City of Pitt Meadows
OFFICE OF THE MAYOR

Re: CP Logistics Park: Vancouver – City of Pitt Meadows’ Assessment of CP’s Environmental Effects Evaluation and Select Technical Studies

The purpose of this letter is to provide the City of Pitt Meadows’ (City) response to CP’s Environmental Effects Evaluation (EEE), and select technical studies for the proposed CP Logistics Park: Vancouver project (Logistics Park, Proposed Project).

Figure 1 – City Unconstructed Highways

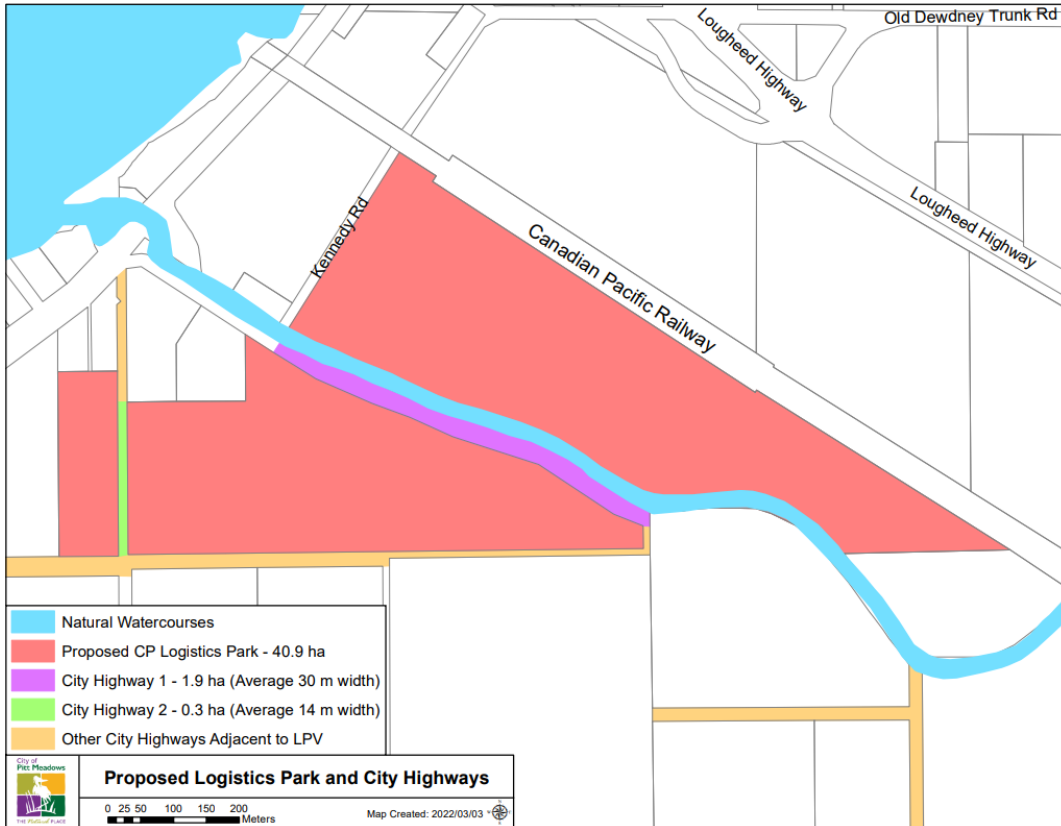
As shown in Figures 1 & 2, the Proposed Project site layout shows four road and rail crossings of City unconstructed highways, including three crossings of the City’s future McTavish Connector.

Figure 3 – Lack of Traffic Analysis in Vicinity of City’s Unconstructed Highways (CP, with City Edits)

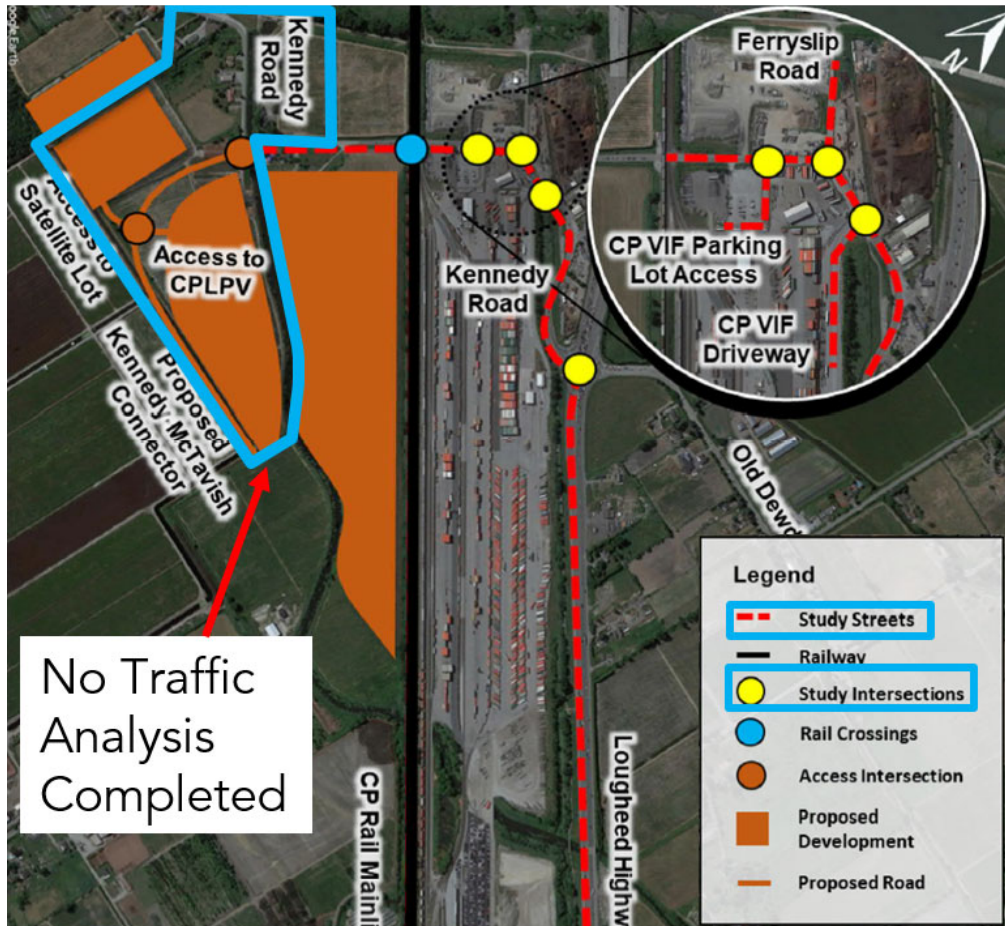
CP had an opportunity to identify, consider, and propose mitigation for LPV impacts to the City's unconstructed highways by including the McTavish Connector (both in its current location and CP's proposed location), as well as Kennedy Road west of the LPV site (as Kennedy Road ties into either configuration of the McTavish Connector), in their Transportation Impact Study (Transportation Study). Instead, as shown below in Figure 3, this area was omitted from the Transportation Study. Without conducting any traffic analysis, it is unreasonable for CP to state that the impacts of the LPV to the City's unconstructed highways, including McTavish Connector, have been adequately identified or mitigated. Therefore, CP's assessment that "no significant Project-related residual or cumulative effects on transportation are expected" is incorrect.

Figure 4 – Expected Preload Volumes for Logistics Park

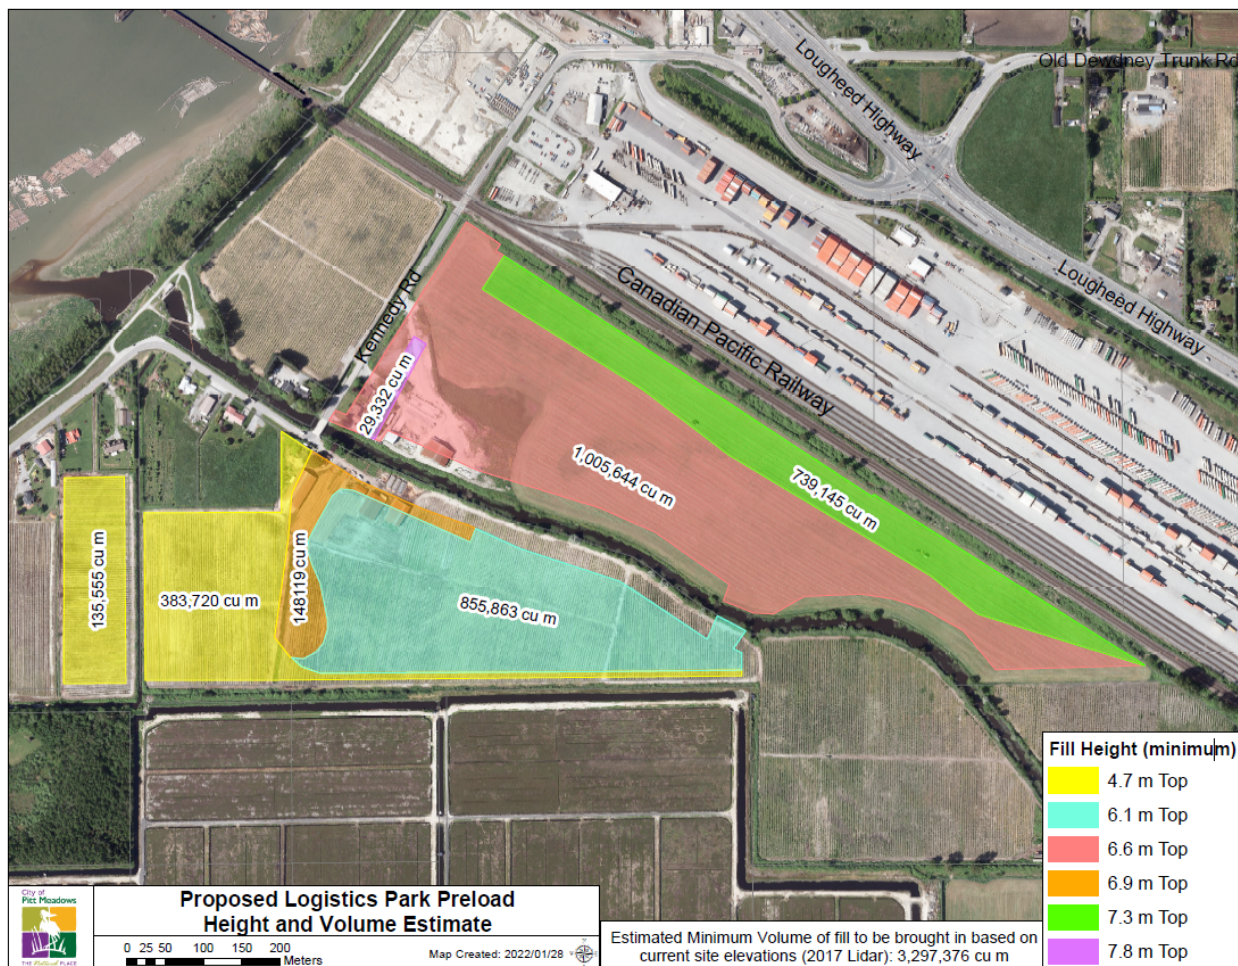
With respect to granular material required for the LPV site, the City anticipates that the volume of material required will be much more extensive than for VIF. When comparing recent topographic maps with preload drawings that CP provided, the City estimates that CP will need to import approximately 3,297,376m³ of preload material. Note that this estimate excludes additional volumes required to replace topsoil that will be stripped, as well as, the toe of the preload slopes; therefore, the actual preload volume required is likely to be greater. Refer to Figure 4 below:

Figure 7 – Proximity of Construction Works (Including Piling) to Property Line (CP, with City Edits)

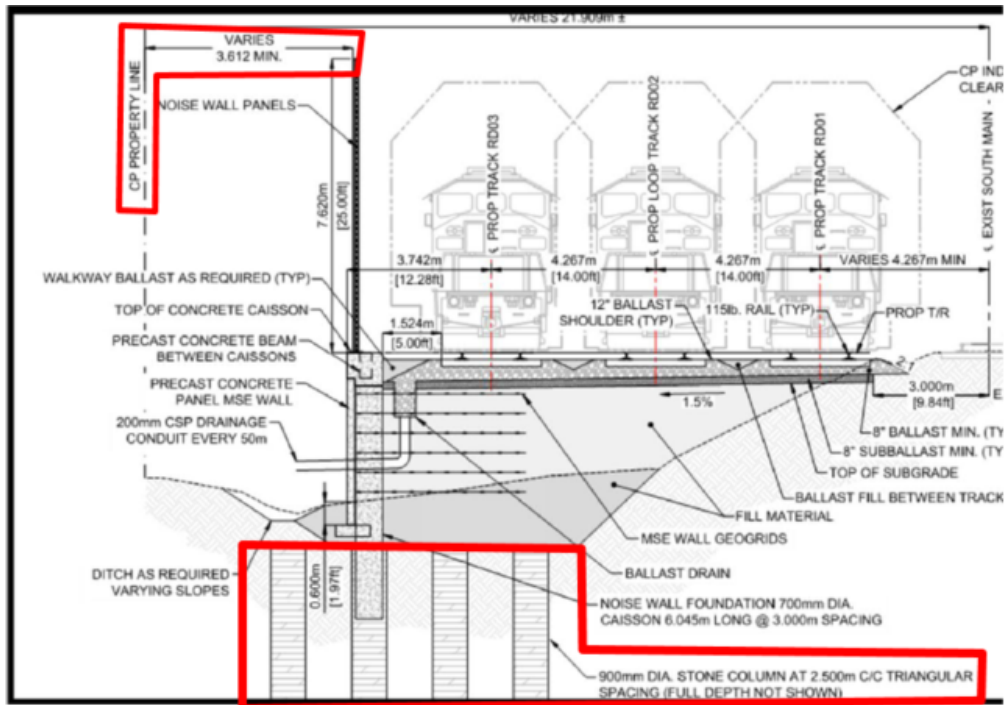
CP states that a quantitative assessment of potential noise effects for the LPV was not completed as "full information on construction equipment required, schedule of activities, and duration of use are not currently available" and that "assessment of noise effects during pre-construction and construction is done qualitatively". This conclusion is an immense error in judgement and a significant oversight; the pre-construction and construction works (such as piling, which is typically considered highly invasive) will occur as close as 6.5 meters to certain existing residences. This will have a substantial quantitative impact and require substantial mitigation. Figures 7 and 8 below provide a visual of the proximity of the construction work to existing residences:

Figure 9 – Existing High Annoyance Day/Night (L_{dn}) Noise Levels within the Vicinity of the Proposed LPV (RWDI, with City Edits)

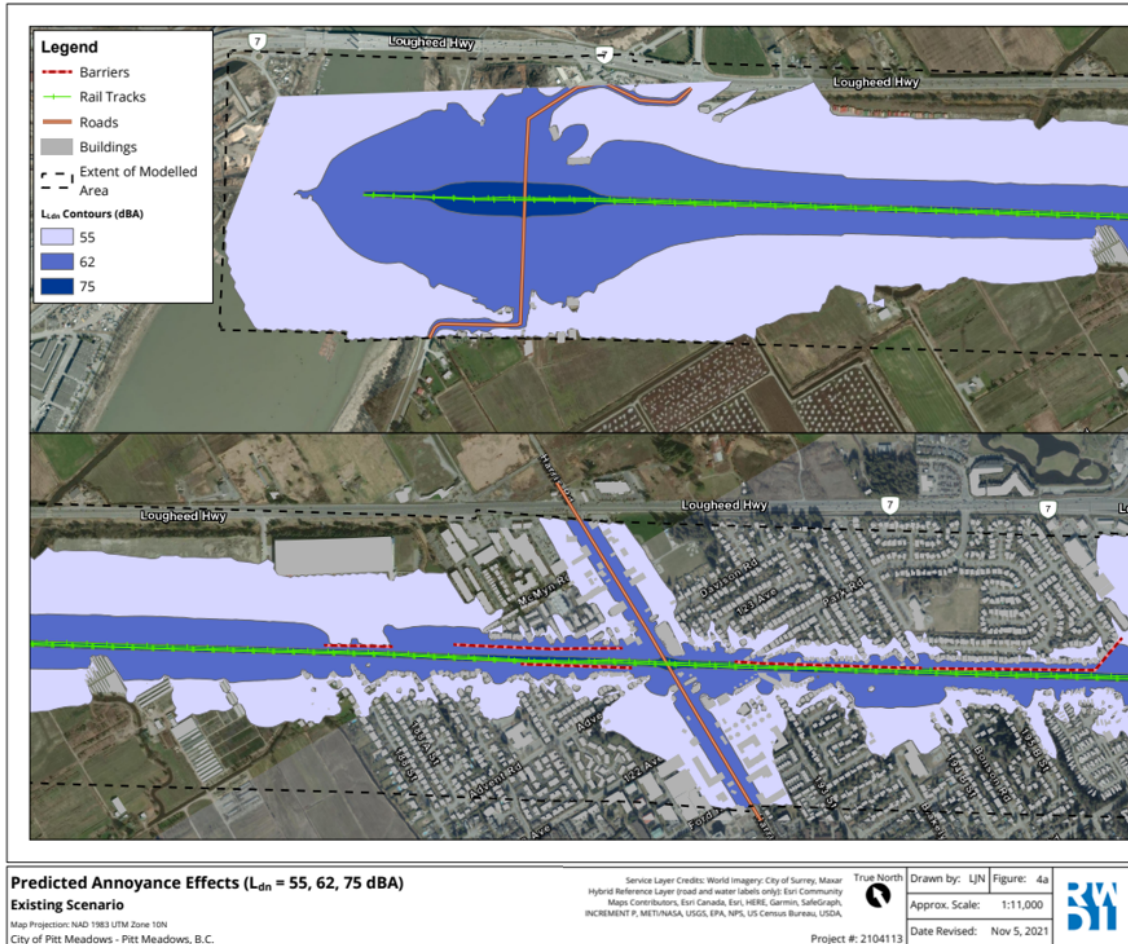
Within their Cumulative Effects Evaluation in Section 10.5, CP fails to consider the interaction between VIF, mainline tracks, Maersk Facility and the LPV. As identified by BKL’s and RWDI’s reports, the baseline conditions in the vicinity of VIF, Maersk Facility, the mainline tracks, and the LPV is considerably noisy due to rail and truck activity, and should be considered as part of the cumulative effects. Refer to Figure 9 below:

Figure 1: CP's Proposed Logistics Park and Existing Intermodal Facility
 (from <https://vancouverlogisticspark.ca/consultation-and-engagement/>, visited Feb. 4, 2022)

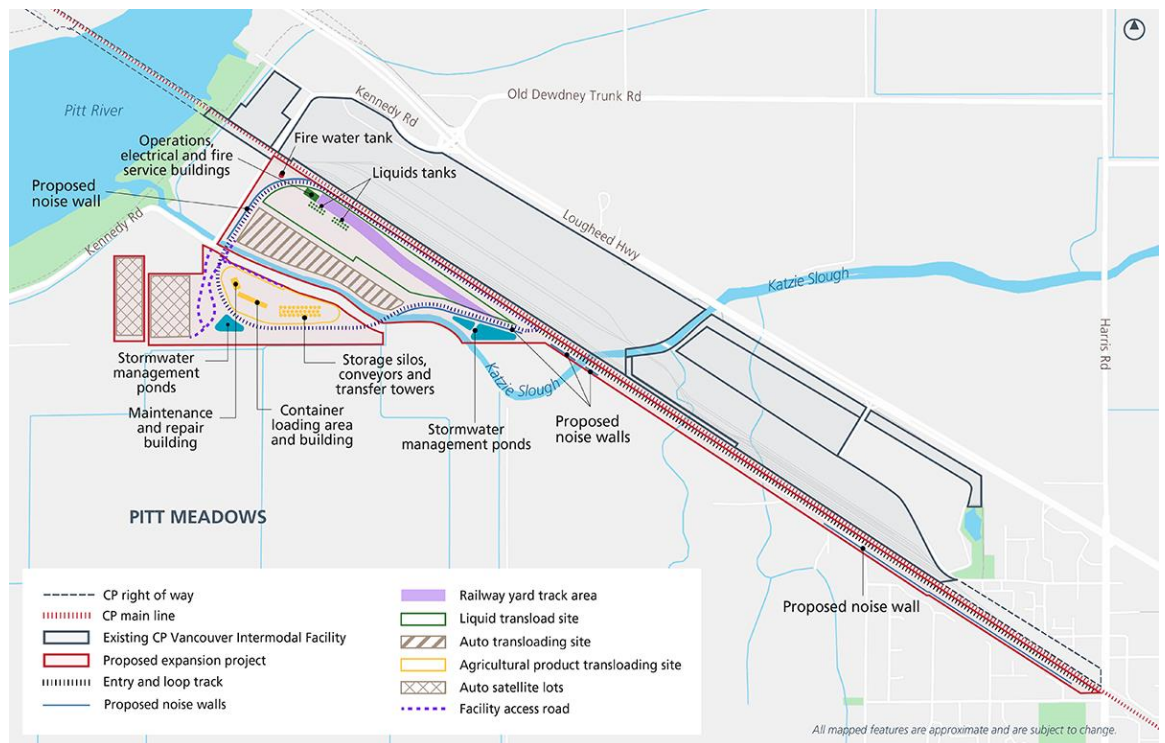
1. Based on a review of the spatial boundary, the Project area is limited to the new proposed Project lands only which are south of the mainline as shown in Figure 1 below. However, the EEE states that, for CP, the proposed Project is: "...an expansion to its existing, adjacent Vancouver Intermodal Facility...".² The Minister of Environment and Climate Change's

decision³ to not designate this Project under the *Impact Assessment Act* was based on the proposed logistics hub being an expansion to the VIF resulting in a less than 50% increase in total area per the Impact Assessment Agency of Canada’s Analysis Report⁴. As an expansion of the VIF, the VIF should be included within the Project area and be considered cumulatively along with the effects of the new logistics park.

Figure 2: Excerpt from Facility General Arrangement Plan (dated 11/04/2021)

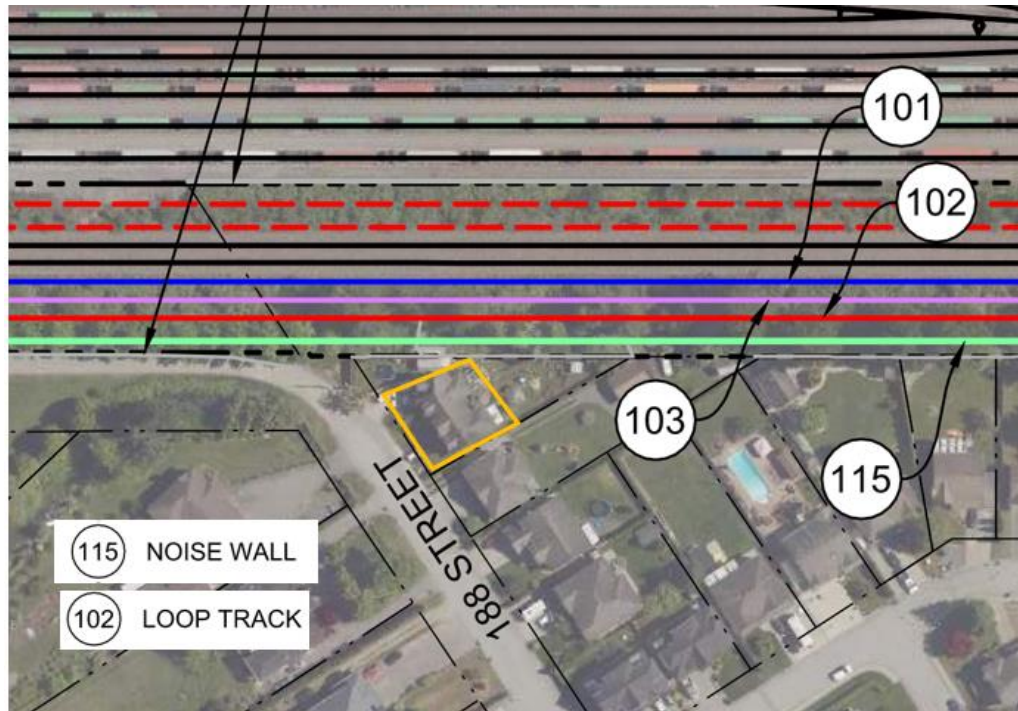
6. Based on the information provided, the construction assessment confidence should be rated “low” (no data) not “medium”. The magnitude could be “high”, particularly for noise from pile driving given the proximity to homes to the Project area (i.e., homes are within 16 m of the proposed loop track and even closer to proposed retaining walls). An excerpt from the Project's Facility General Arrangement Plan is provided in Figure 2 which shows the proximity of the closest identified home (12548 188 St., Pitt Meadows, BC) to the proposed retaining/noise wall and the proposed loop track. There is no indication of the location, type, or duration of piled driving in the EEE, and insufficient discussion or rationale to justify these ratings.

Figure 3: Excerpt from EEE Figure 10.4 showing potential noise contours within the Exiting VIF.

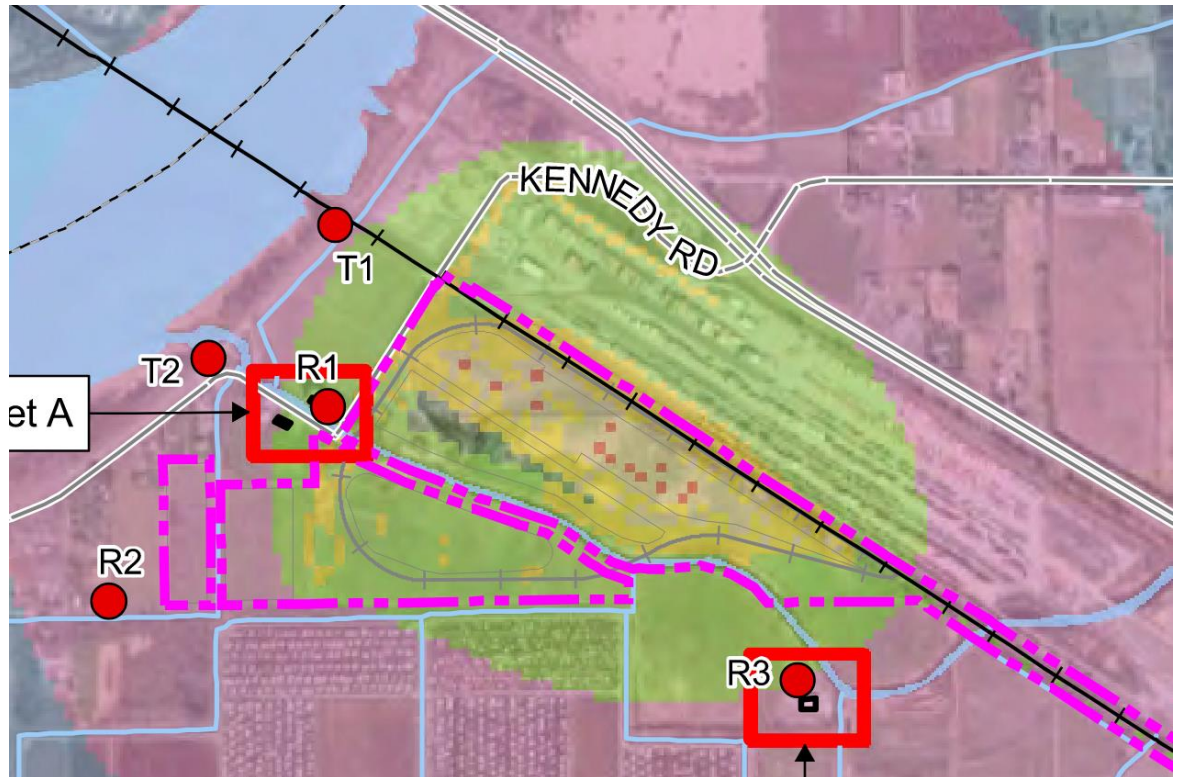
7. Based on a review of the noise contour plots (Figures 10.4 – 10.7), it appears that there may be noise sources modelled within the existing VIF. An excerpt of Figure 10.4 from the EEE is provided in Figure 3 below (see faint yellow areas within the existing VIF which appears to identify a 70 – 80 dBA region).

All noise sources within the Project area should be defined. In addition, given the proposed Project is an expansion of the existing VIF, future VIF operations should be incorporated into the analysis. Only the existing VIF contributions appear to be included in the analysis as part of the existing baseline and are not included as part of the project contributions.

Figure ES-5: Pitt Meadows Road and Rail Improvements Project Summary (Vancouver Fraser Port Authority, 2020)

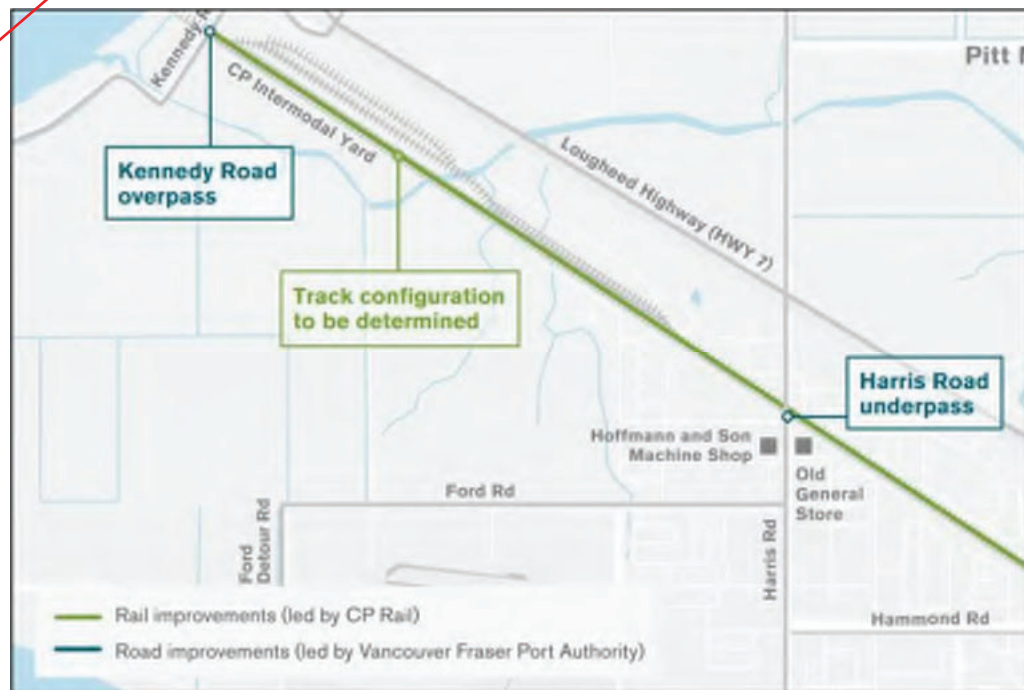
Locations or extents?
